MISSISSAUGA BUS RAPID TRANSIT

ENVIRONMENTAL ASSESSMENT ADDENDUM

March 2010

McCormick Rankin Corporation
in association with
Ecoplans, Ltd.

McCORMICK RANKIN CORPORATION	MISSISSAUGA Transportation and Works	DATE: August 2008	MISSISSAUGA BRT PROJECT ENVIRONMENTAL ASSESSMENT ADDENDUM		FIGURE 5-2
			SCALE: 1:1,000	WINSTON CHURCHILL BOULEVARD / HWY 403 INTERCHANGE ALTERNATIVE B: BUSWAY OVER EXISTING RAMP LAYOUT

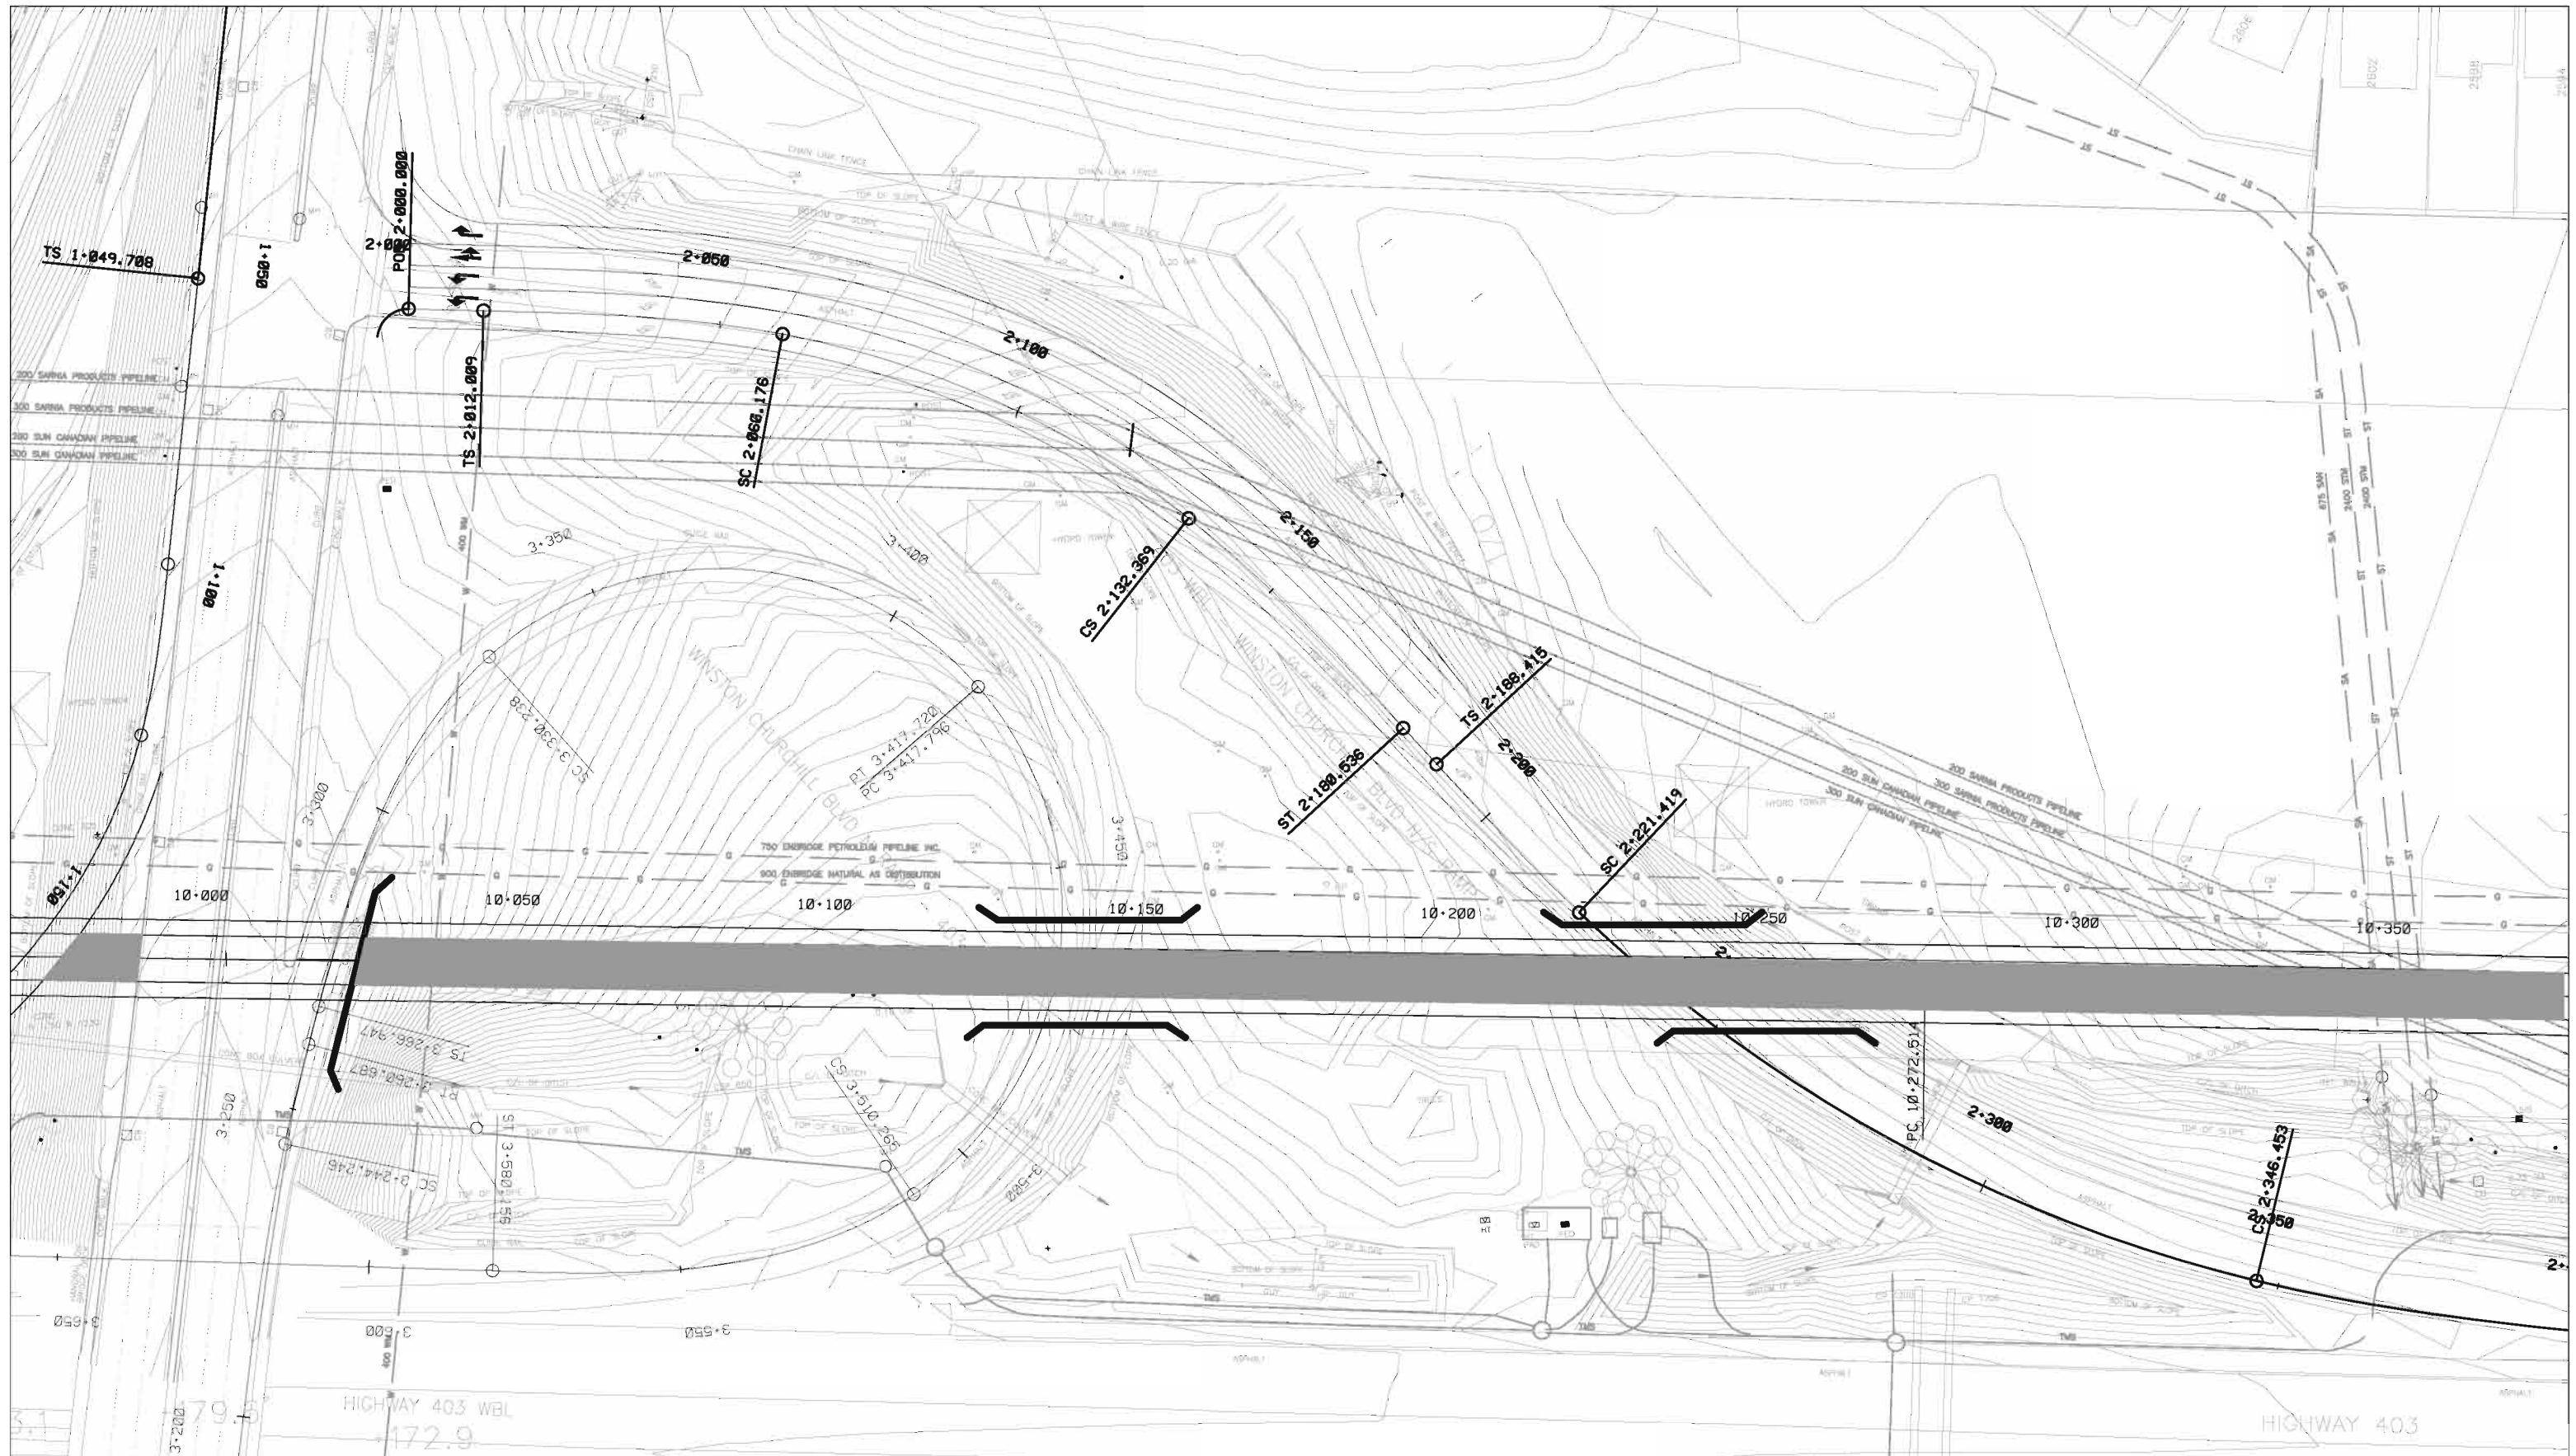
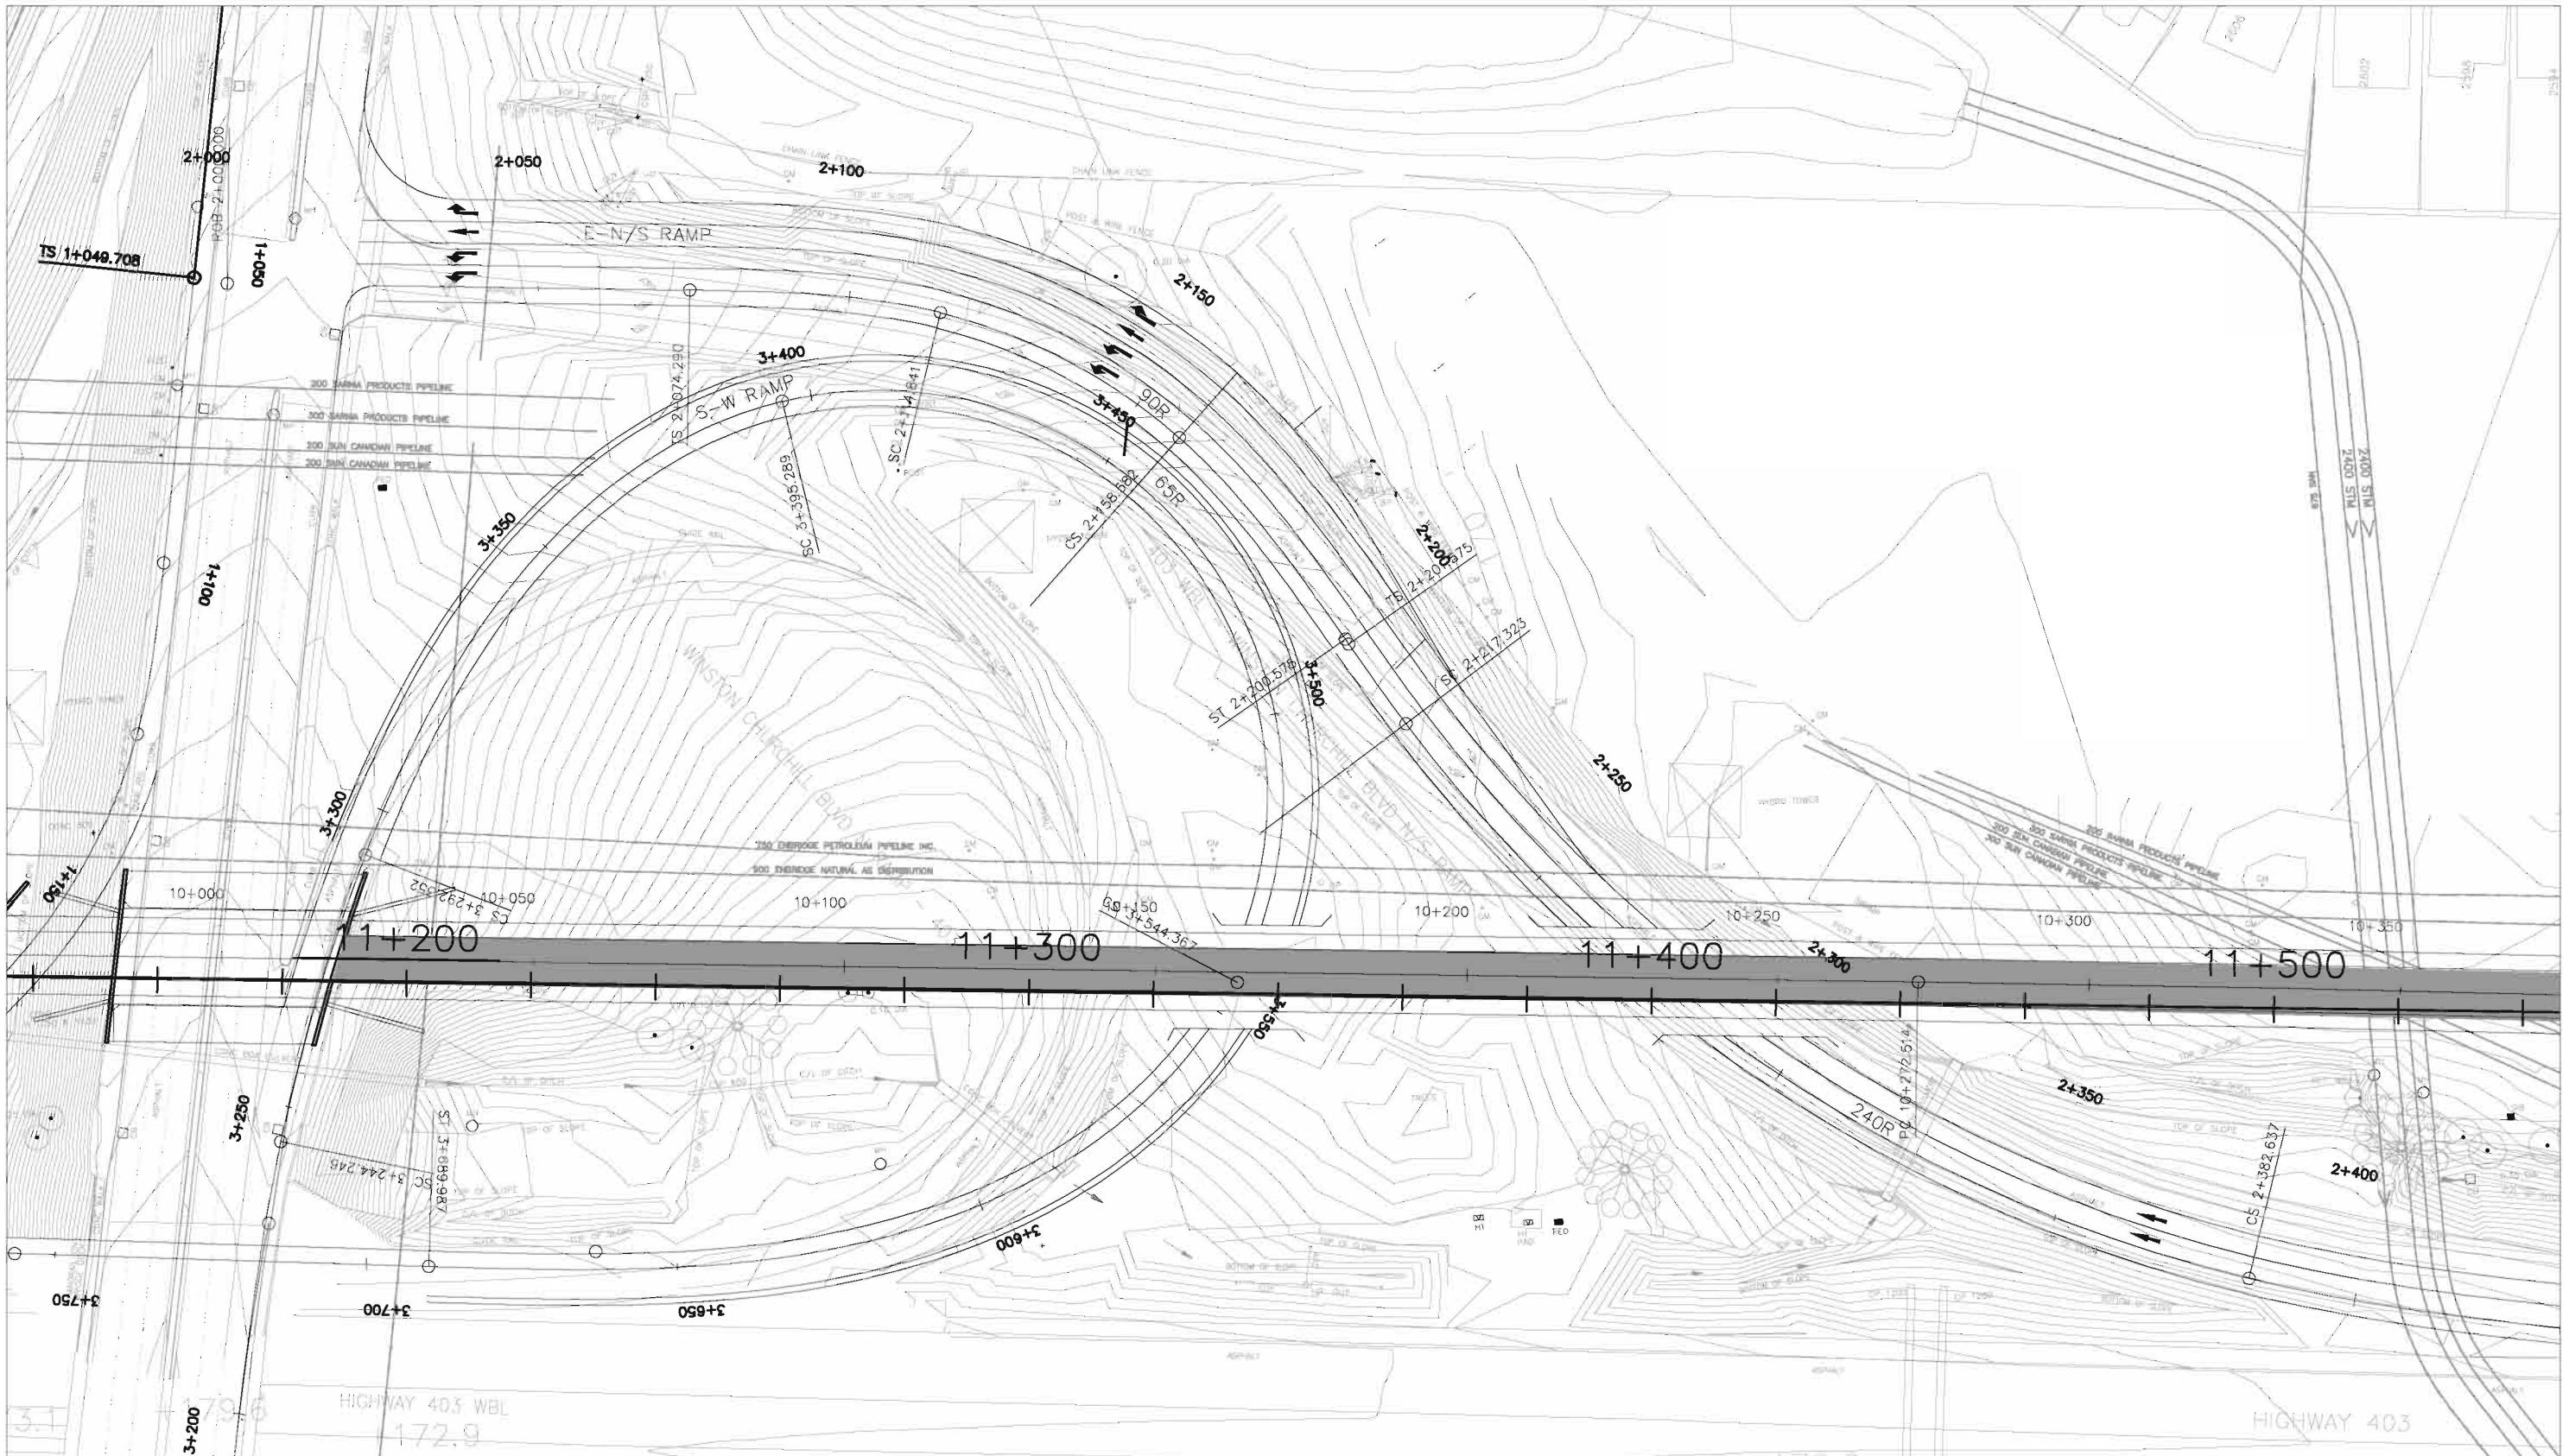
The alternative of crossing over the ramps is significantly less costly than going under. The impacts of these options on the community are both minor and mitigatable. Of the two “over” options, the one involving a realigned S-W loop ramp is less costly and incrementally better in most respects. The recommended alternative is shown on Figure 5-3.
